## Product Change Notification / ASER-23WWAI681

CCB 4235 Final Notice: Qualification of MMT as a new final test site for selected Atmel AT27C/BV/LVxxxPU/JUxxx products

**PCN # ASER-23WWAI681**  
**CCB 4235\_Pre and Post Change Summary**

PLCC 32 COVER TAPE (Width: 24mm)

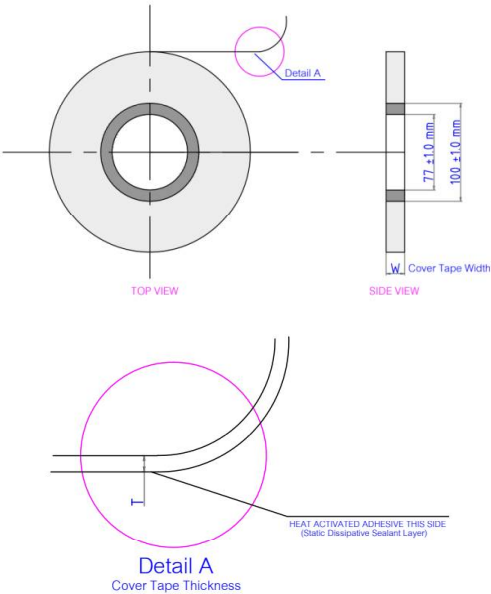
Carrier Width	Supplier	MCHP P/N	Supplier Part	Width "W" (mm)	Thickness (mm)	Sealing Mythology
24mm	Sumitomo	22102002	CSL-Z7302	21.0 +/- 0.1	0.050 ±0.010	Heat Sealing

PLCC 44 COVER TAPE (Width: 32mm)

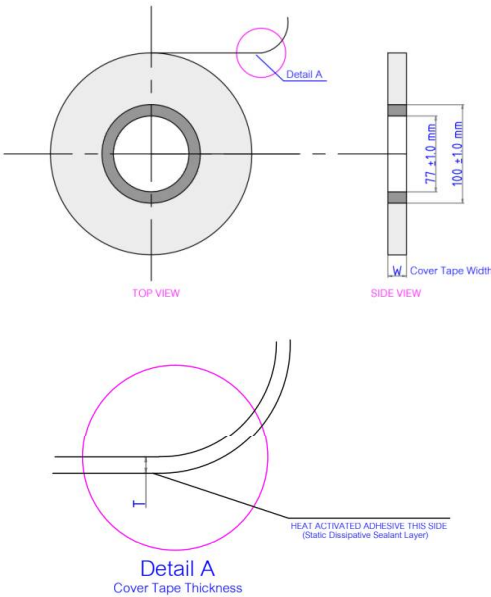
Carrier Width	Supplier	MCHP P/N	Supplier Part	Width "W" (mm)	Thickness (mm)	Sealing Mythology
32mm	Sumitomo	22104401	CSL-Z7302	25.5 +/- 0.1	0.050 ±0.010	Heat Sealing

## PLASTIC REEL: WIDTH 24mm

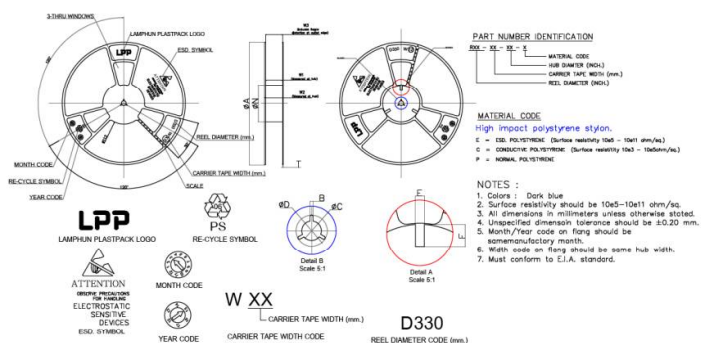
Width	MCHP P/N	Supplier Part	Hub	Color
24mm	23000024	R13-24-04-E	4inch (100mm)	Dark Blue

Description	MPHIL	MMT
Color	White	Dark blue
Diameter	329.99 +/- 1.0	330 +/- 2.0
Hub	100	100 +/- 2.0
Width	25.5 +/- 0.5	24.4 +2.00/-0.00

## PLASTIC REEL: WIDTH 32mm

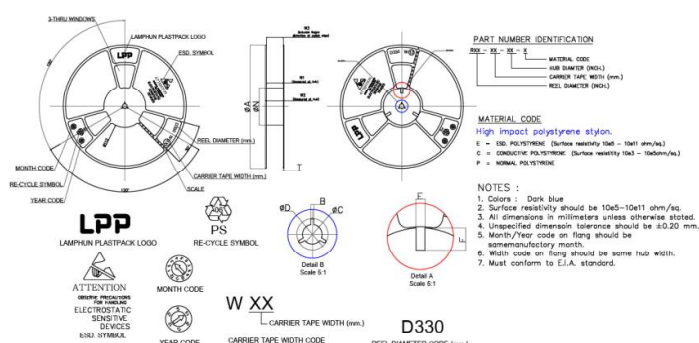
Width	MCHP P/N	Supplier Part	Hub	Color
32mm	23000023	R13-32-04-E	4inch (100mm)	Dark Blue

Description	MPHIL	MMT
Color	White	Dark blue
Diameter	329.99 +/- 1.0	330 +/- 2.0
Hub	100	100 +/- 2.0
Width	33 +/- 0.5	32.4 +/- 2.0
